Your Ref
AL/102/18/HH
Our Ref
PLAN-025178
Date
15/11/2018

Proposal: Two storey side extension to house & detached garage with hobbies room above.
Site: The Red House, Westergate Street, Westergate, PO20 3QZ.
AL/102/18/HH

Due to surface water inundation issues in the Lidsey Catchment "The applicant is advised to adopt, where appropriate, the measures in the table "Practical measures to reduce the potential impacts of development".

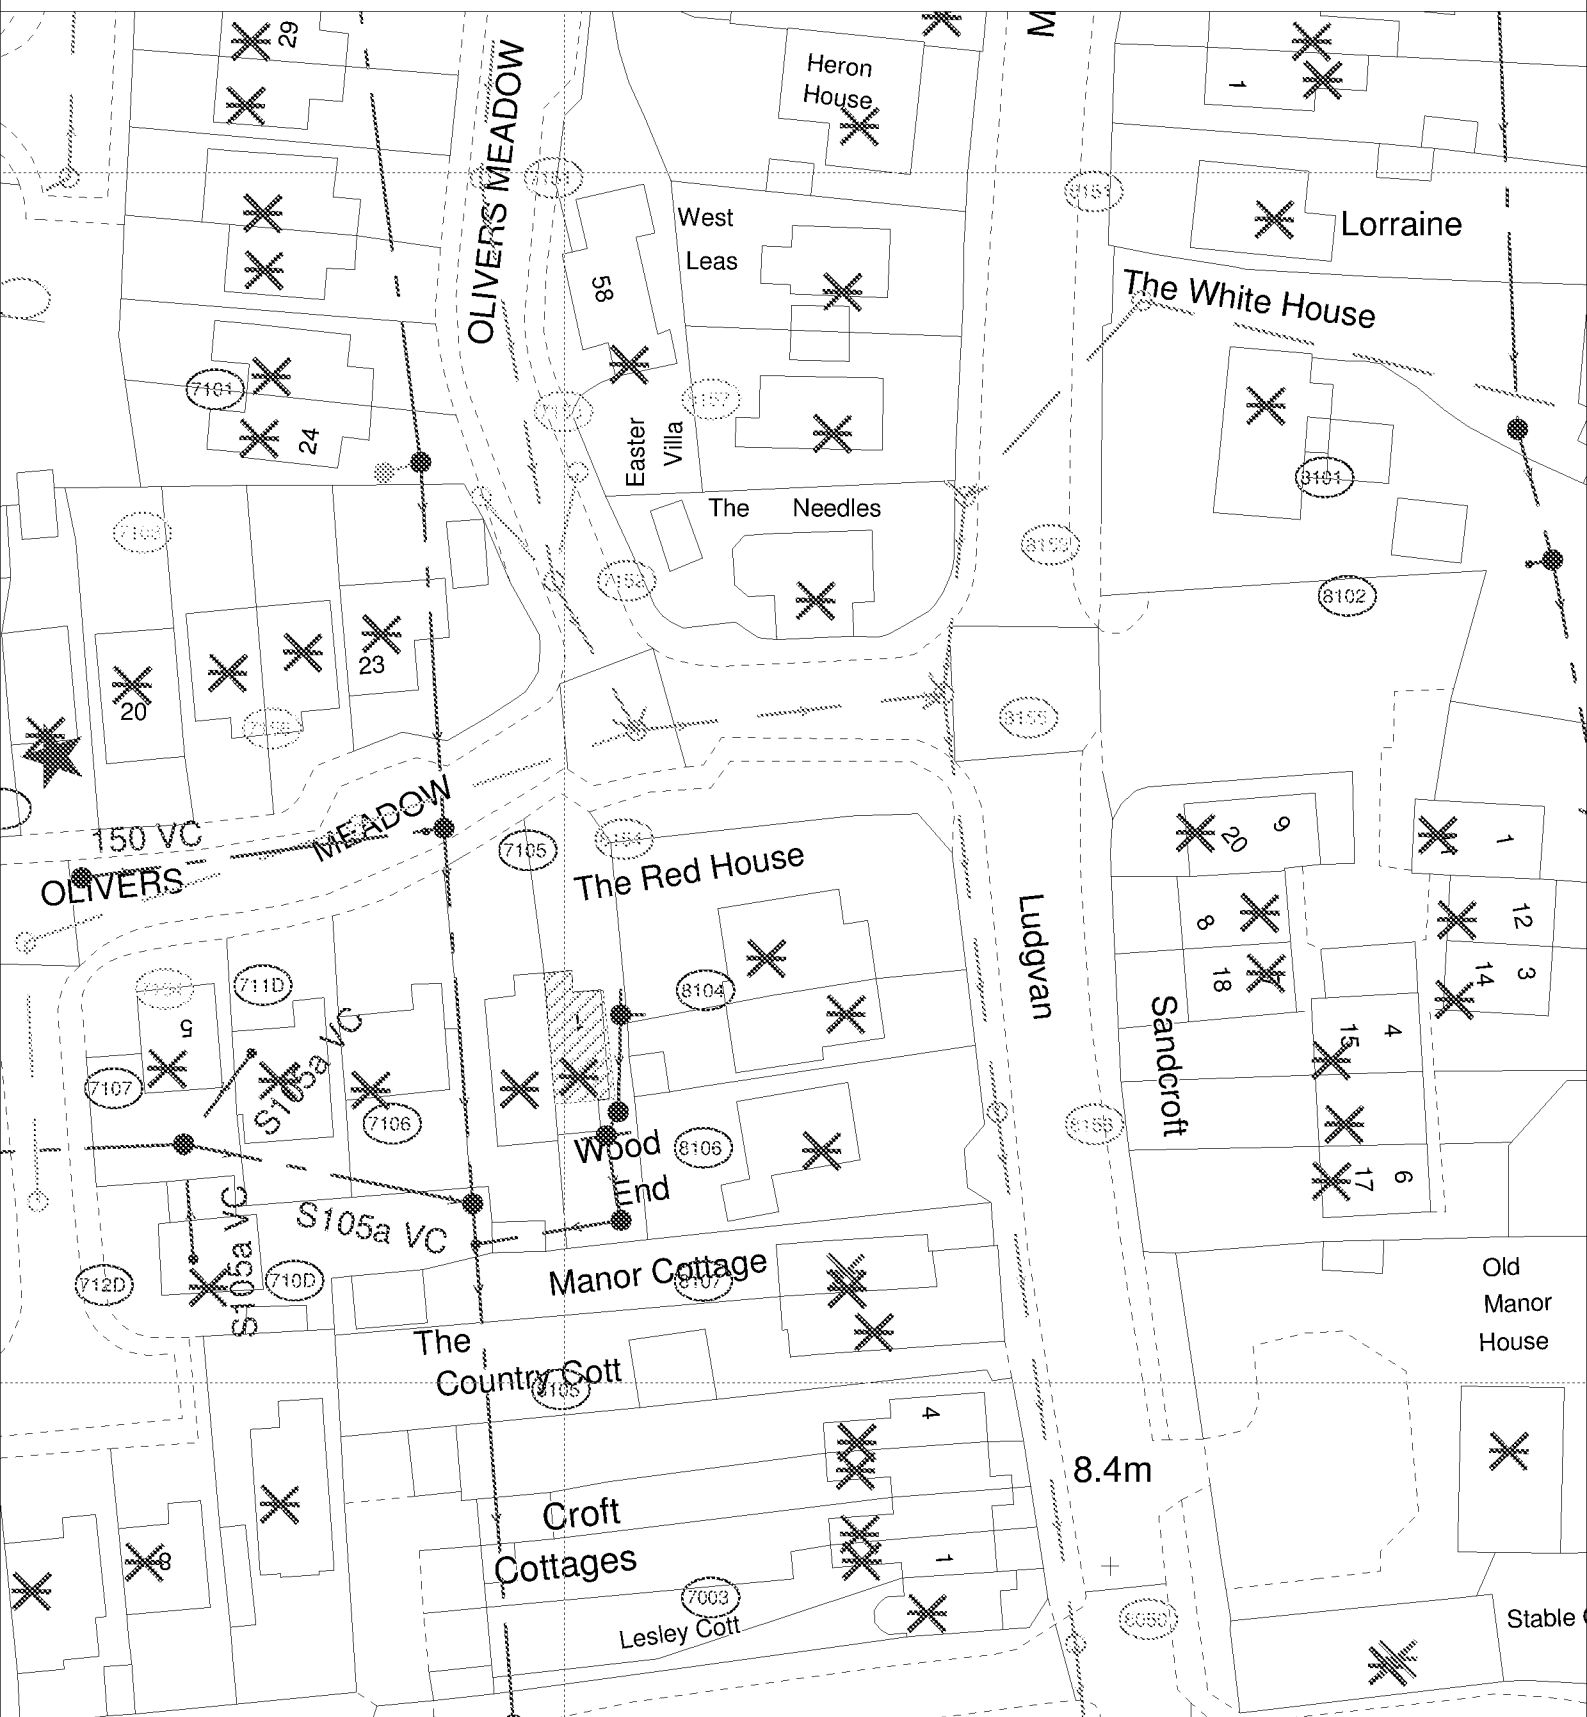
Developer should look to protect the public sewerage system from inundation and infiltration, which contribute to flooding in unfavourable conditions.
